COMMUNITY BOARD FEEDBACK PACKAGE

COMMUNITY BOARD RECOMMENDATION FORM

Business Name: EMPIRE DINER

Application Number: 20240716010013

Sidewalk Cafe Site Plan Form

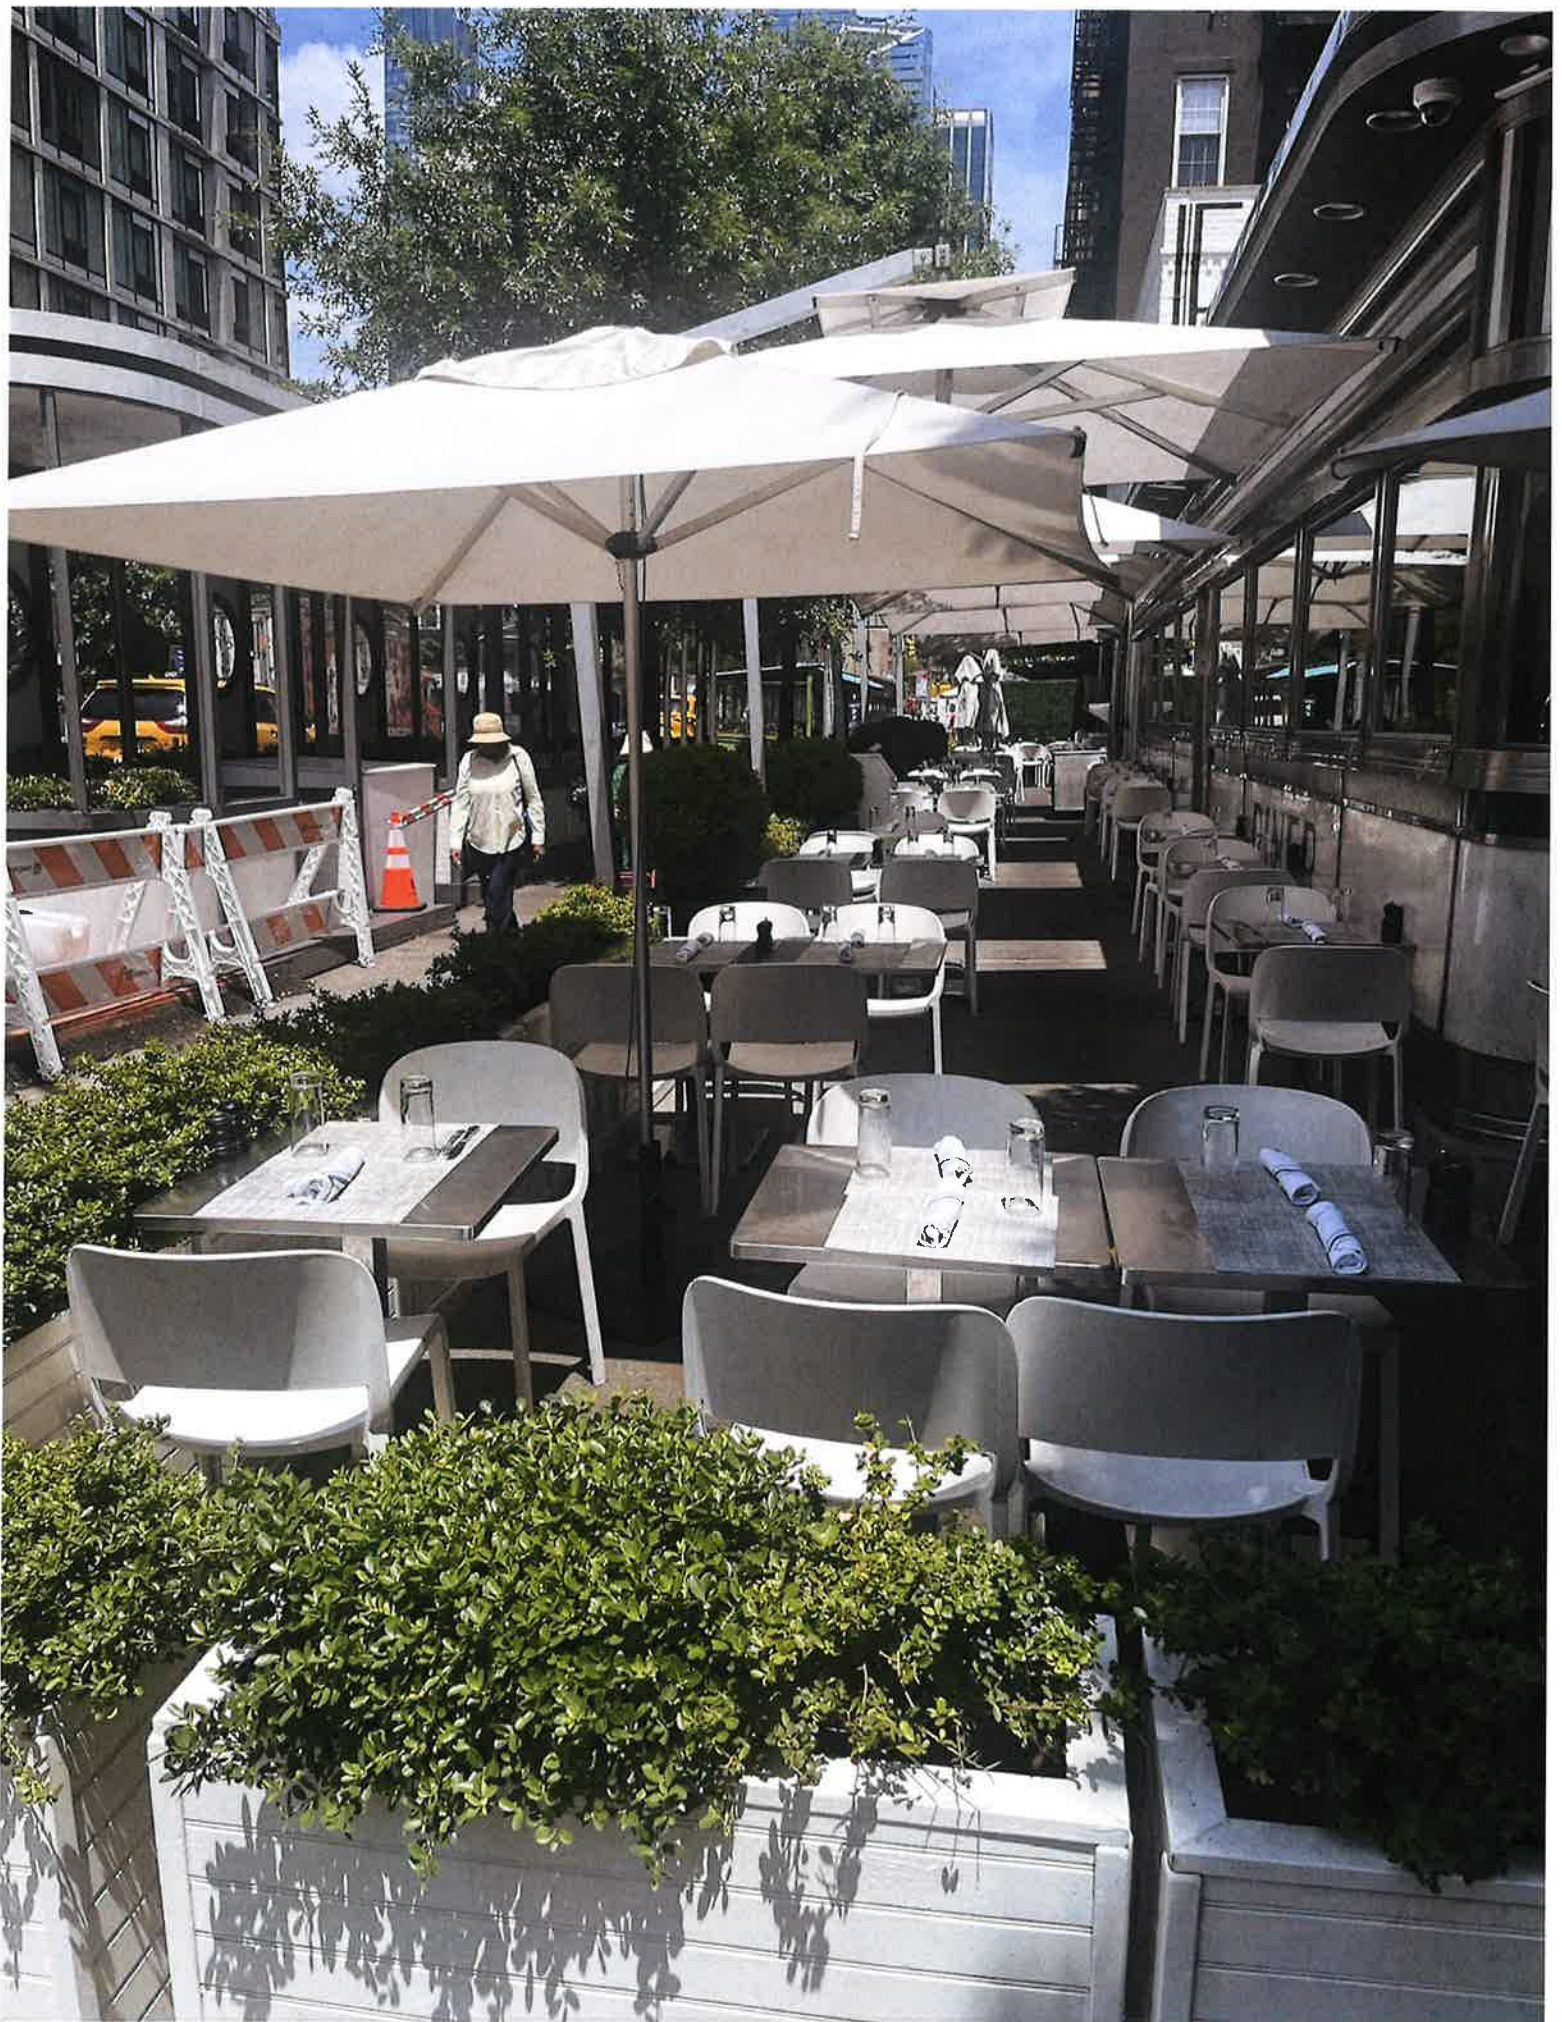
Comments related to the cafe's physical footprint and dimensions: The proposed Site Plan has multiple problematic aspects.

First, the plan does not reflect in any way several obstructions on the sidewalk including the pedestrian ramp at the corner of 10th Avenue/W.22nd Street and, along the 10th Avenue sidewalk, a parking meter (next to the fire hydrant) and a traffic sign (next to the traffic signal pole). Second, the plan itself provides inadequate clearances, such as allowing only 8 feet, rather than the required 10 feet, between the cafe perimeter and the directly-opposite fire hydrant and street light at the north end. Third, and most fundamentally, the plan does not provide for the required 10 foot clear path: there are points (such as around the tree pits) where the clear path according to plan itself is only 8 feet; and the clear path weaves into indentations in the sidewalk cafe rather than proceeding as straight, uninterrupted path.

This cafe is located on a heavily-trafficked block of 10th Avenue, immediately adjacent to the corner of two major thoroughfares; 10th Avenue and 23rd Street. The location has heavy pedestrian traffic given that it is: across the street from Clement Clarke Moore Park (frequented by children and parents with strollers); in the middle of the Chelsea gallery district; and only 1-1/2 blocks from the extremely popular High Line. There are at least 8 existing sidewalk obstructions immediately opposite or adjacent to the proposed cafe, which already seriously impede pedestrian flow. Community members also have observed that the sidewalk is often crowded with Empire Diner customers waiting for tables.

MCB4 recommends Denial, unless the cafe Site Plan were reconfigured to provide for the required 10 foot pedestrian clear path in a straight line for the entire length of the cafe. Although it is difficult to be exact about the modifications needed, it would appear this would require removing the 5 tables/10 seats at the corner of Tenth Avenue/W.22nd Street and reducing the rest of the cafe to a line of tables with four seats each against the wall of the establishment plus the required service aisle.
